Source: Prestolite Electric Ltd - Greenford, London, UK  
Date: September 22, 2011  
Bulletin No: TSB4043 (Rev.01)  
Models: Alternator 66021590M  
Subject: Wiring instructions

### Replacement of 66021590 with 66021590M (Insulated return)

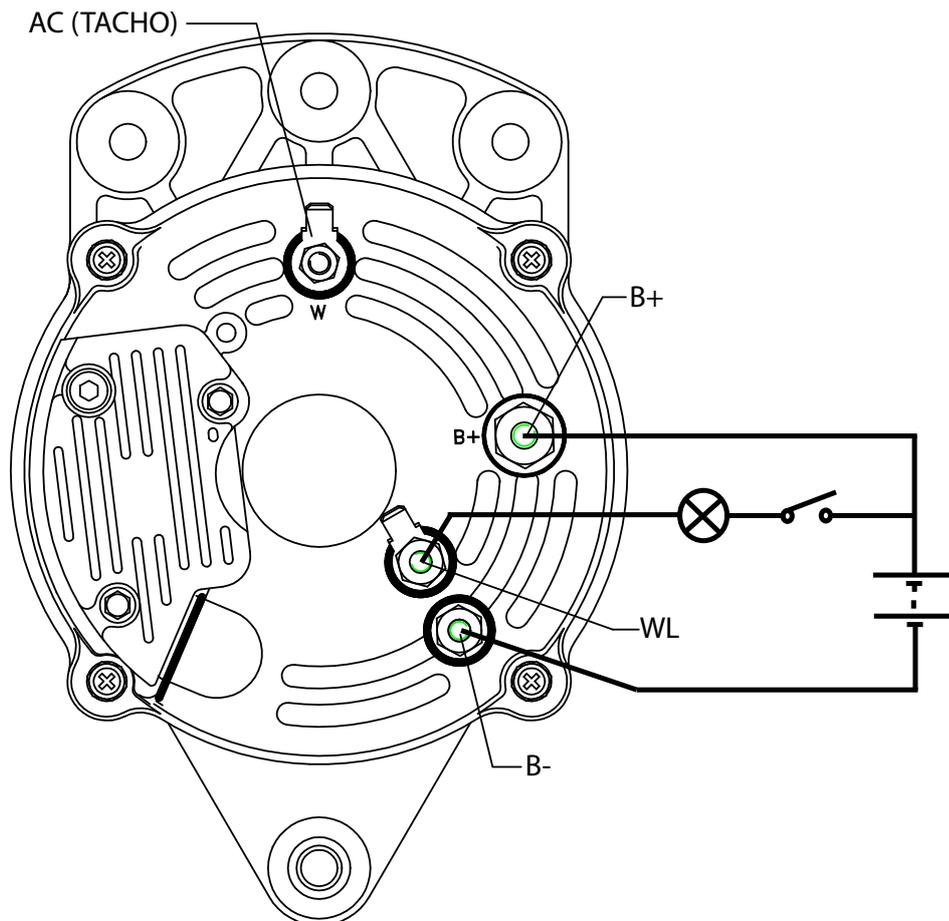
The 66021590 has been discontinued and replaced by the 66021590M. The "M" version is a marinised version of the older 66021590, and has the addition of a B- terminal which is insulated from the frame of the alternator. Therefore B- connection must be made from the alternator B- terminal to the battery or vehicle frame (if insulated return is not required). Please see diagram below:

B+ (Battery positive connection)  
B- (Battery negative connection)  
WL (Warning lamp connection)  
AC (Tacho connection)
